## STAFF REPORT

### CITY OF COLUMBUS PLAN COMMISSION (November 12, 2015 Meeting)

**Docket No. / Project Title:** PP-15-05 (Woodland Parks Major Subdivision Replat)  
**Staff:** Allie Keen  
**Applicant:** Skaggs Development, LLC  
**Property Size:** 47.76 Acres  
**Current Zoning:** RS2 (Residential: Single-Family 2)  
**Location:** West side of US 31, approximately 567 feet north of County Road 400 North, in German Township. Block D1 is specifically located between 5995 and 1862 Conifer Court.

PRELIMINARY PLAT

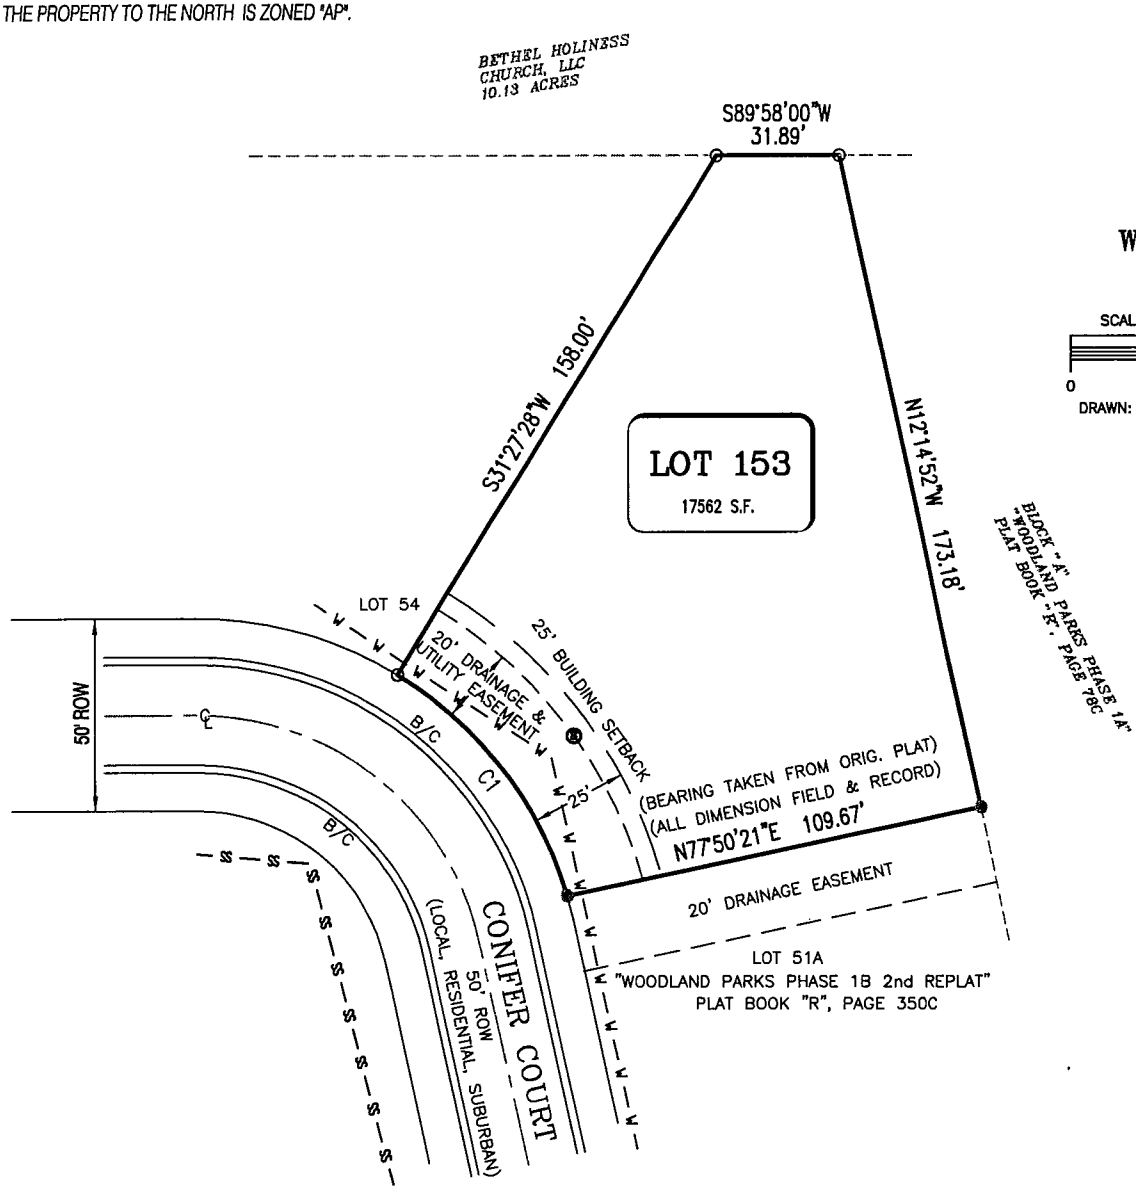
1. There is an outstanding rezoning for the Woodland Parks Subdivision from February 2014 as a condition of approval of that rezoning. The following items from the Engineering punch list still need to be taken care of prior to the rezoning being finalized.
  - a. Woodland Parks 1A:
    - i. Lots 1, 6, 7, and 8 still have the same issues as they did in 2005 with the cross slope of the walks through the driveways and walk.
    - ii. Asphalt is rutting before you get to Phase 1B, this should be fixed prior to the City accepting.
  - b. Woodland Parks Phase 1B:
    - i. The developer has finished constructing Buckthorn Drive. They have installed some walk however it all needs to check for ADA compliance. Engineering will need to set up a final inspection.
2. The performance bond for Sections 1A and 1B have expired; new bonds need to be provided.

2. Block D1 is approximately 17,562 square feet in size and is consistent with the other lot sizes within the subdivision. The new lot will be served by an existing interior subdivision street, Conifer Court.

5. There are currently 3 other blocks (Block A, Block B, and Block C) in Woodland Parks. Block C is intended to be additional building lots and Blocks A and B are retention ponds. Both of these ponds can get access from Woodland Parks Drive if Block D1 is changed to a building lot with this request.

Approval, the infrastructure is already in place to support 1 additional building lot and the loss of the common area will not adversely affect the neighborhood. The approval should be subject to the following conditions:

1. The outstanding issues with the unfinished public infrastructure for Sections 1A and 1B according to the conditions of approval for the Woodland Parks rezoning (RZ-13-07) shall be addressed prior to the approval of the next final plat for this subdivision (including that which would create the currently proposed lot).
2. A replacement performance bond shall be provided for the public infrastructure in Sections 1A and 1B prior to the approval of the next final plat for this subdivision (including that which would create the currently proposed lot).
